LR-N11-0122

Hope Creek Generating Station
Facility Operating License No. NPF-57
NRC Docket No. 50-354

Subject: **RESPONSE TO REQUEST FOR ADDITIONAL INFORMATION, LICENSE
AMENDMENT REQUEST – OPERATION WITH FINAL FEEDWATER
TEMPERATURE REDUCTION AND FEEDWATER HEATERS OUT-OF-SERVICE**

REQUEST FOR ADDITIONAL INFORMATION (RAI)
REGARDING PROPOSED LICENSE AMENDMENT
OPERATION WITH FINAL FEEDWATER TEMPERATURE REDUCTION
AND FEEDWATER HEATERS OUT-OF-SERVICE
HOPE CREEK GENERATING STATION
DOCKET NO. 50-354

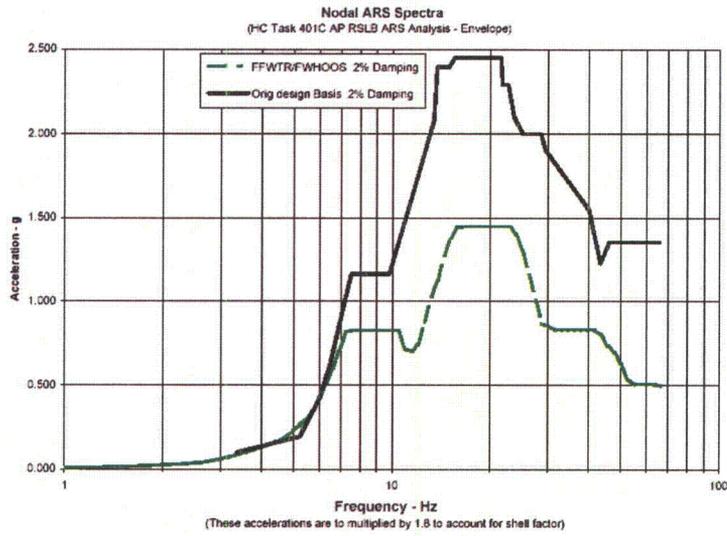
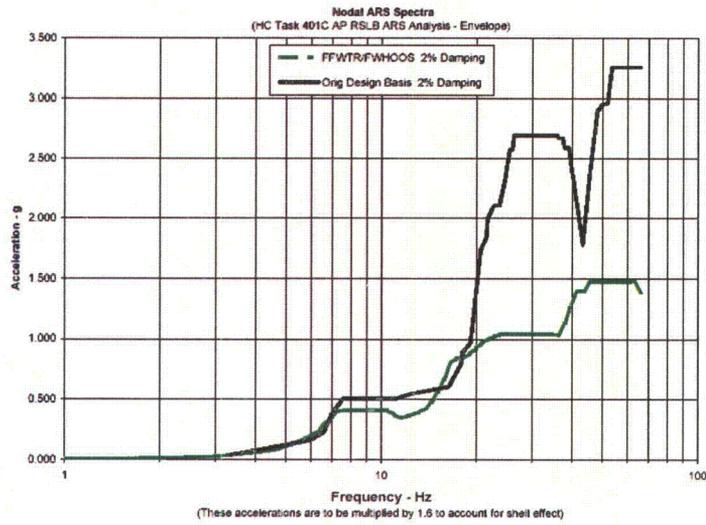
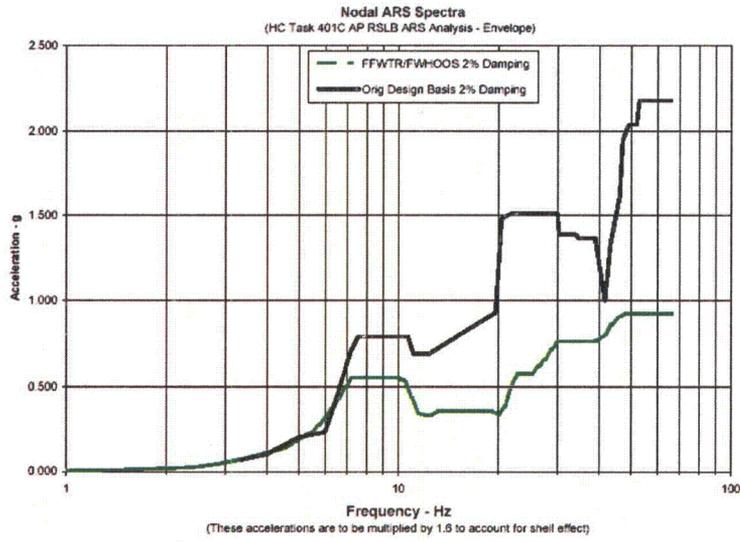
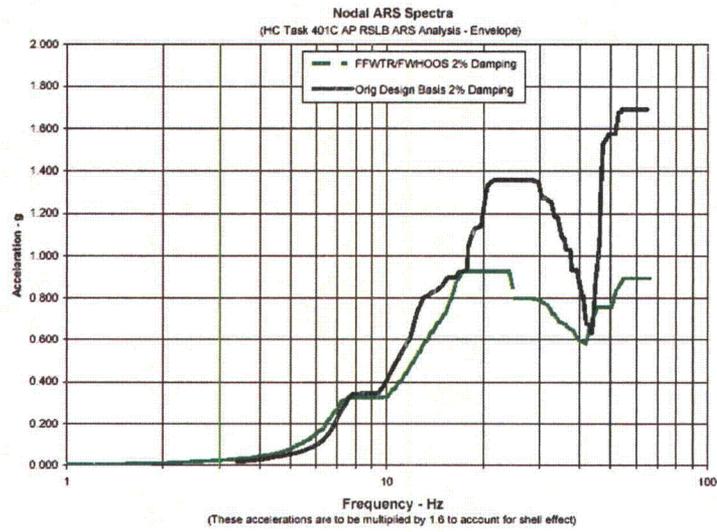
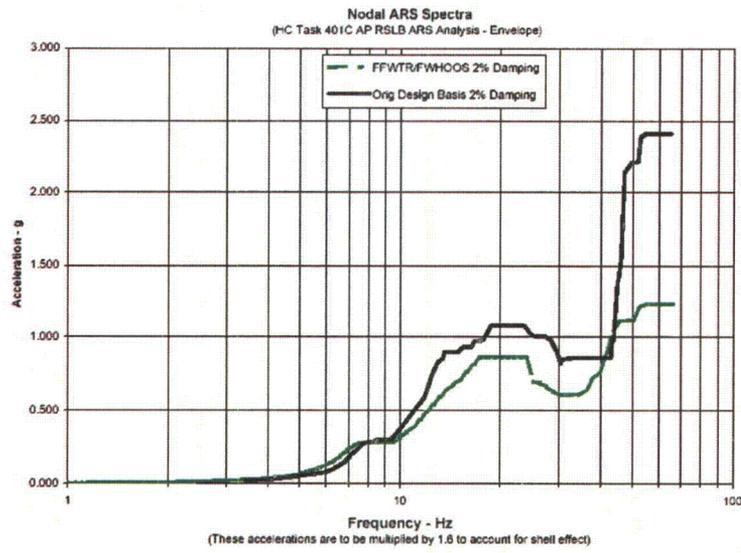
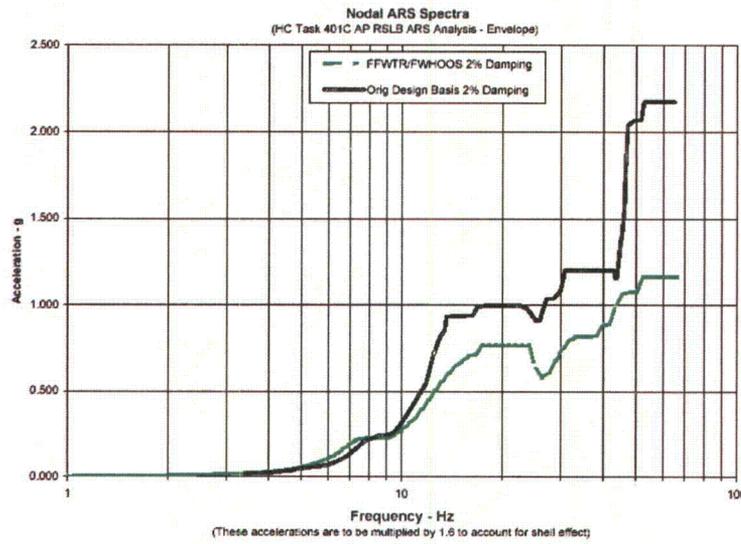
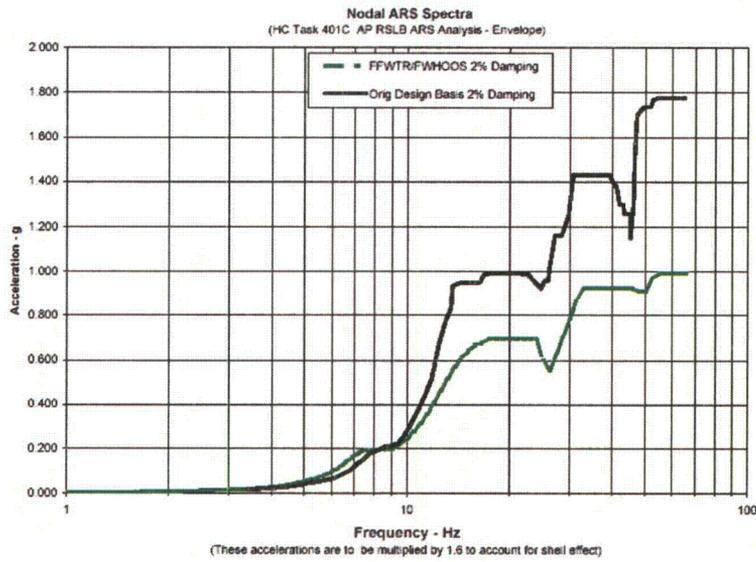
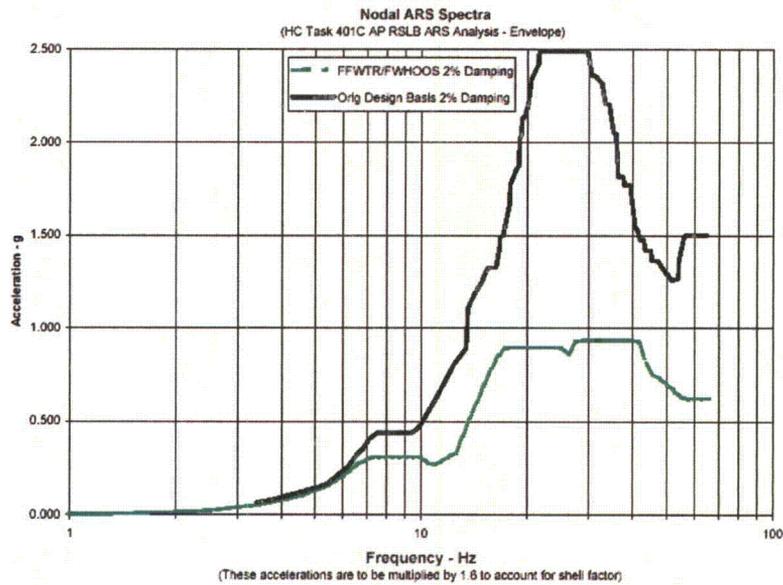
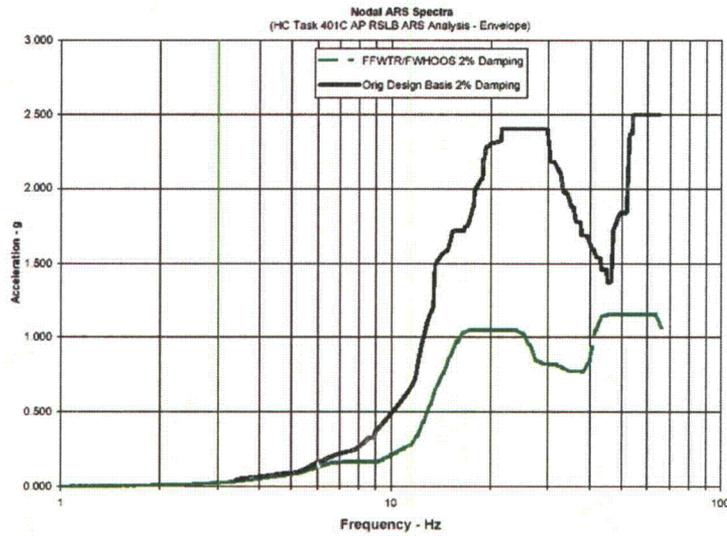
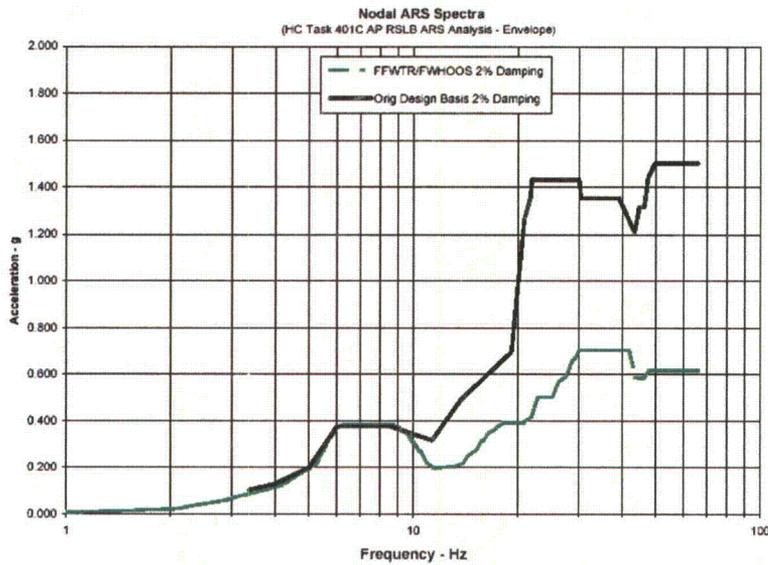
With respect to NEDC-33506P, Section 5.4, "Reactor Coolant Pressure Boundary Piping," please discuss how the AP loads have changed based on the proposed amendment. In addition, provide summaries for the reactor coolant pressure boundary pipe stresses and fatigue CUFs and pipe supports/restraints and compare these values to the Code allowable values to support your statement that, "The results of those evaluations showed with the change in AP loads, the stresses on the piping, supports, and restraints will continue to meet the applicable ASME Code requirements."

The effects on the AP loads due to the FFWTR/FWHOOS conditions on the AP amplified response spectra (ARS) are shown on Figures C-2, C-4, C-6, C-7, C-8, C-10, C-11, C-13, C-18, and C-19 compared to the original design AP ARS for various locations inside the containment. The original design AP ARS with 2% damping are in black color and the FFWTR/FWHOOS condition AP ARS with 2% damping are in green color.

The MS B piping analysis results of FFWTR/FWWHOOS AP ARS were compared with those of the original design basis. Based on the comparison, it is observed that the original design basis loads bound current FFWTR/FWWHOOS AP ARS for damping values of 2% analysis for piping stresses and pipe supports loads. The summary of the comparison are as follows.

Main Steam Piping	RSLB Ratio = (FFWTR)/(ORIG)	FWLB ratio = (FFWTR)/(ORIG)
Average MS piping stress ratio	0.666	0.701
Maximum MS piping and branch stress ratio	0.759	0.757
Average Support load ratios	0.682	0.696
Maximum Support load ratios	0.814	0.715

The table shows that the stresses and support loads at the FFWTR/FWWHOOS conditions are less than the results from the original AP load. The minimum margin is 18.6% (100 – 81.4)

The RRS Loop B piping analysis results of FFWTR/FWWHOOS AP ARS were compared with those of the original design basis. Based on the comparison, it is observed that the original design basis loads bound the current FFWTR/FWWHOOS AP ARS for damping values of 2% analysis for piping stresses and pipe supports loads. The summary of the comparisons are as follows.

RRS Piping	RSLB Ratio = (FFWTR)/(ORIG)	FWLB ratio = (FFWTR)/(ORIG)
Average RRS piping stress ratio	0.654	0.660
Maximum RRS piping and branch stress ratio	0.632	0.641
Average Support load ratios	0.586	0.635
Maximum Support load ratios	0.645	0.670

The table shows that the stresses and support loads at FFWTR/FWWHOOS conditions are less than the results from the original AP load. The minimum margin is 33% (100 – 67).

The results of the piping evaluation at the FFWTR/FWHOOS conditions for the AP ARS for the RSLB and FWLB indicate that the piping stresses and piping support loads (forces and moments) are bounded by the original design basis loads of the representative piping systems (MS Line B and RRS Loop B) stresses and support loads. Therefore, the design basis AP ARS responses are bounded for all the piping systems in the RCPB. The conclusions and results support the statement in NEDC-33506P, "The results of those evaluations showed with the change in AP loads, the stresses on the piping, supports, and restraints will continue to meet the applicable ASME Code requirements."
